UNITED STATES PATENT AND TRADEMARK OFFICE

APPLICATION NO.	FILING DATE	FIRST NAMED INVENTOR	ATTORNEY DOCKET NO.	CONFIRMATION NO.
10/086,908	02/28/2002	Will G. Fetherolf	10015361-1	1658

Office Action Summary

DETAILED ACTION

FIG. 2

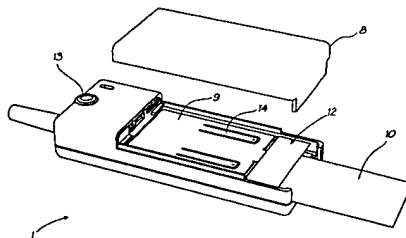
- {claims 6 and 16} print media processing engine (figure 2, reference 12) where the depth is smaller than the height and the width (figure 2, reference 12)

FIG. 3

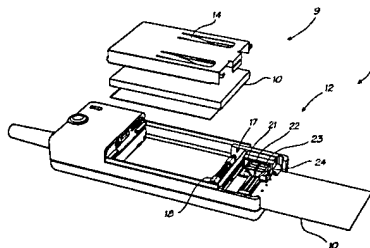
- {claims 11 and 18} media receiver orders a plurality of media (figure 3, reference 9)

received from the media output by gravity force (figure 4, reference 10, 17; inherent because media exits in downward direction and gravity has downward pull)
